Change Order Request

Project: 1923025-02
La Crosse Center Expansion & Renovation
400 La Crosse Street
La Crosse, WI 54601

COR # 112.00

PCO # 179 - Seq 5 CMF Structural Enclosure

2S1-25

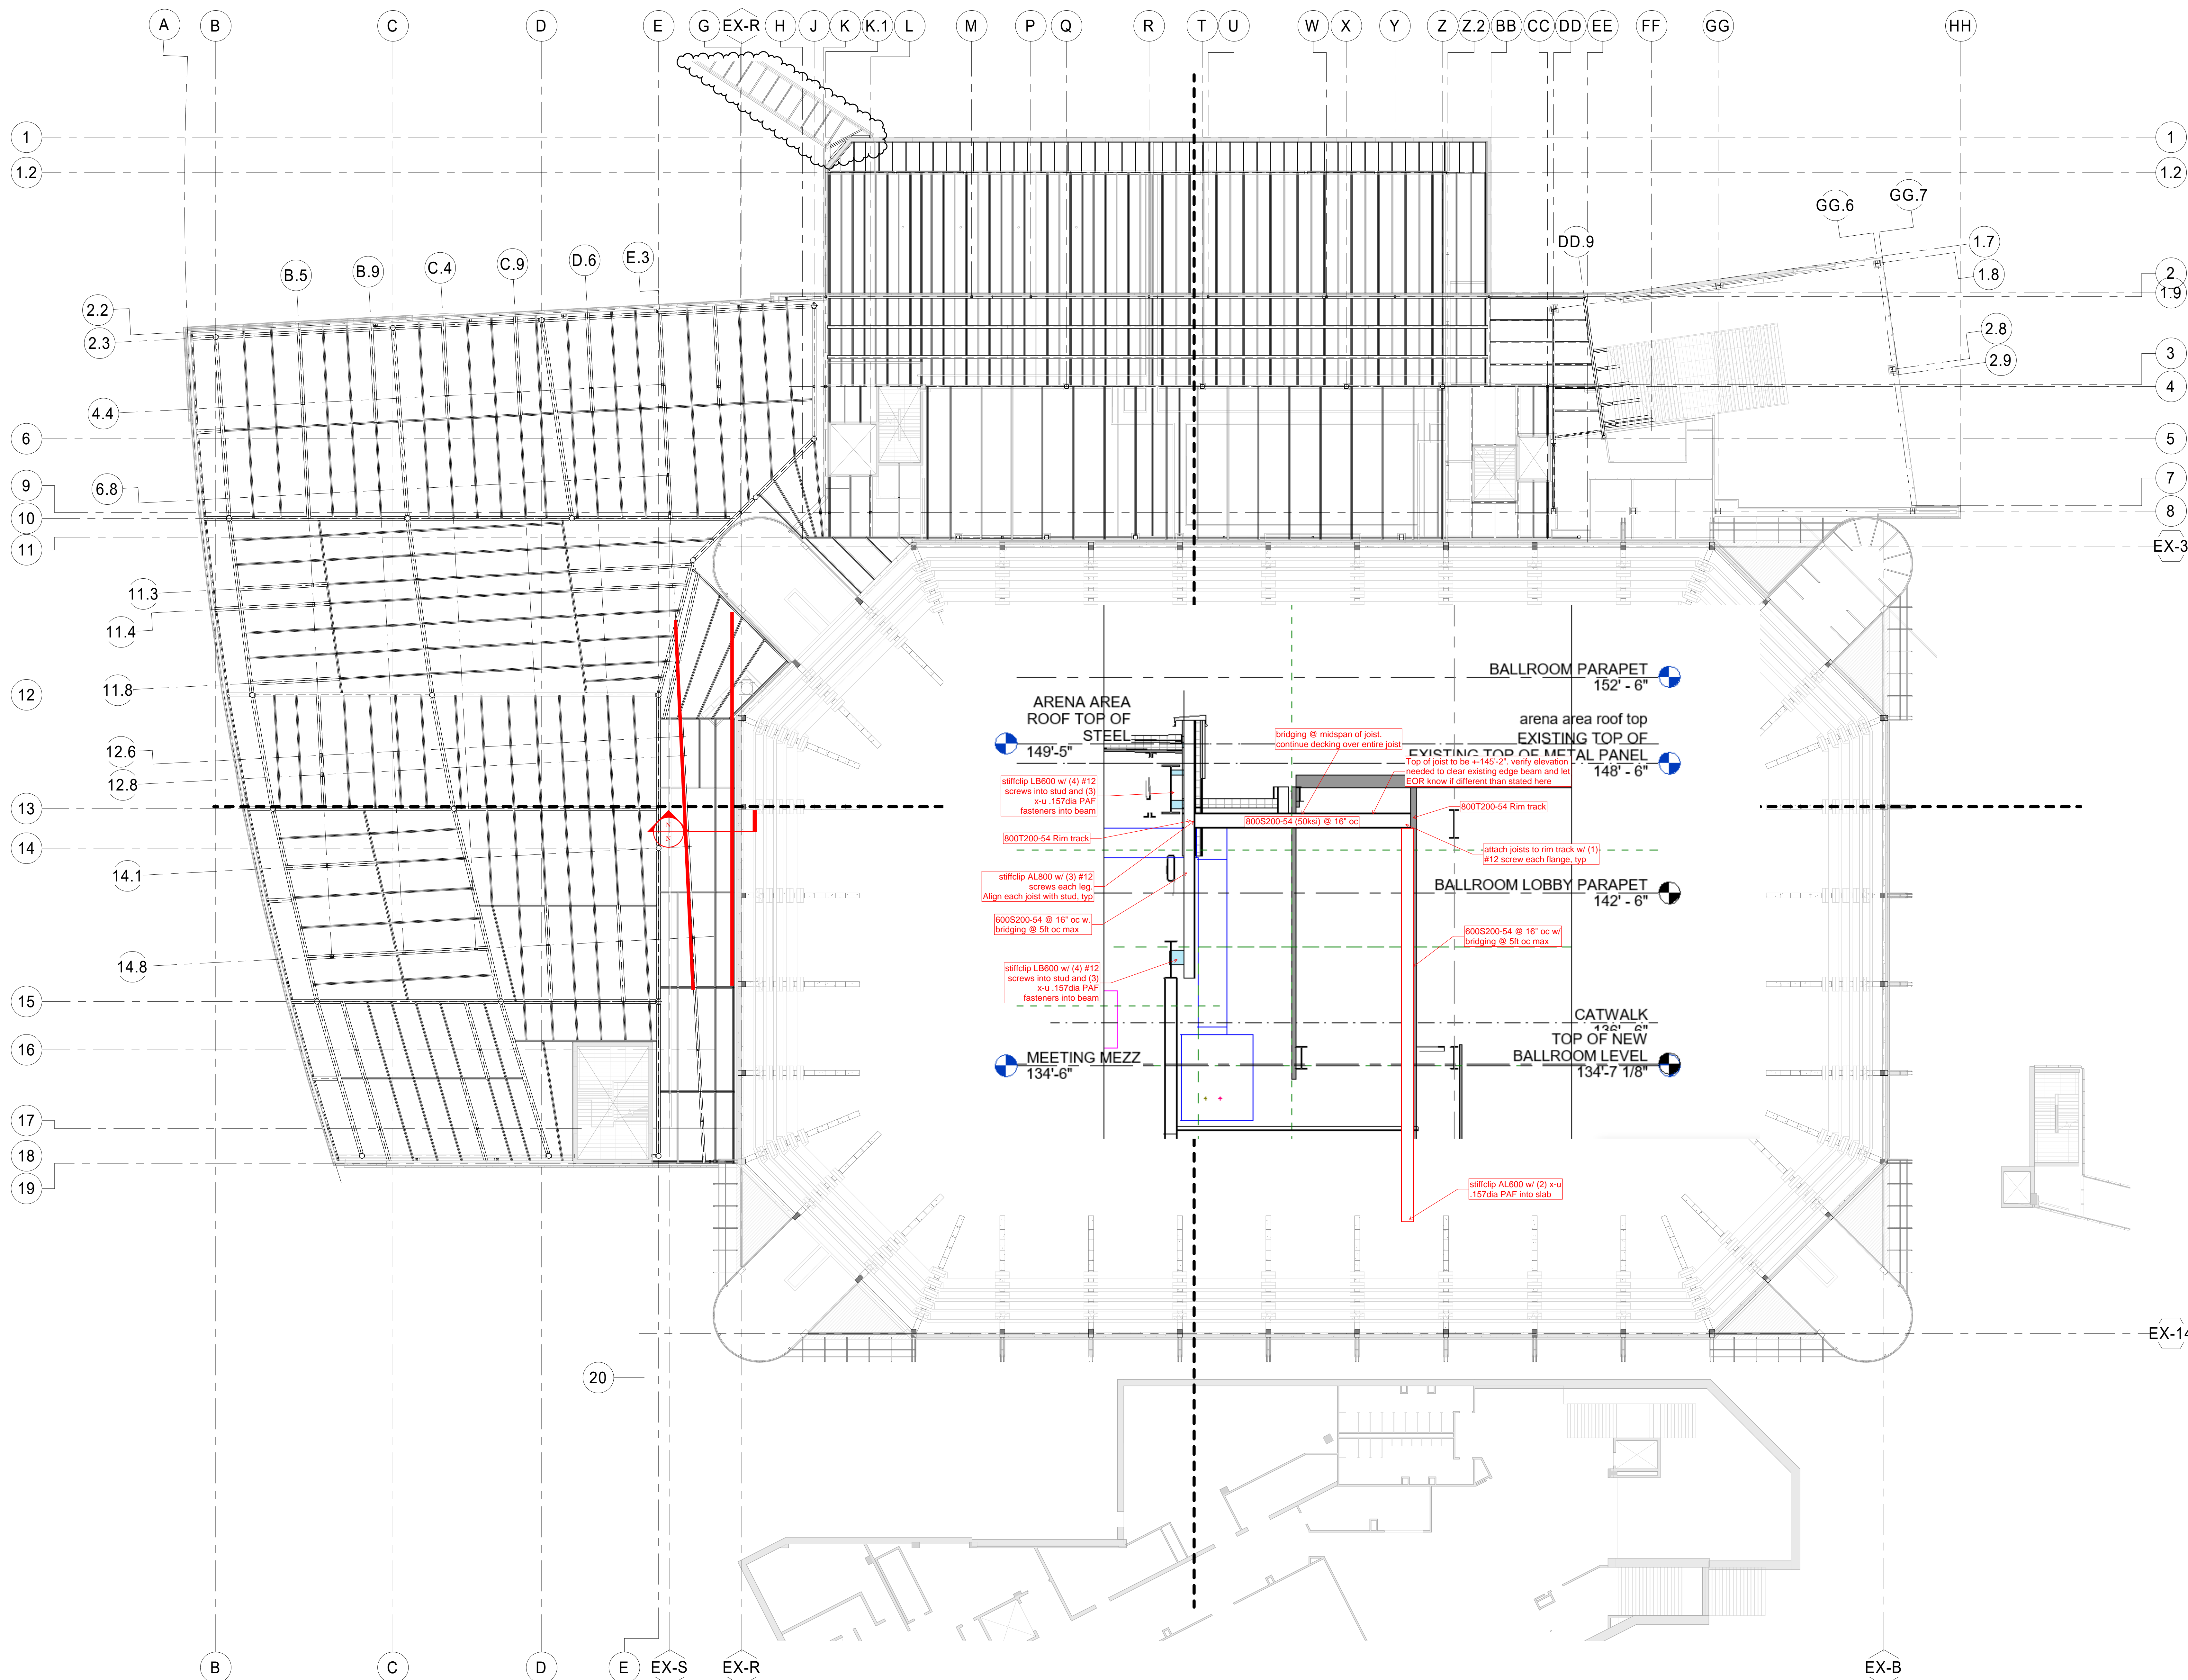
Revised steel sequence 5 to light gauge stud framing due to movement potential from snow loads.

(Credit for East Clerestory framing – 113 LF and for G1 wall – 94LF)

(Add for new East Clerestory framing – 113 LF, bearing wall adjacent to existing arena wall – 94 LF, and 8” joist ceiling – 94 LF)
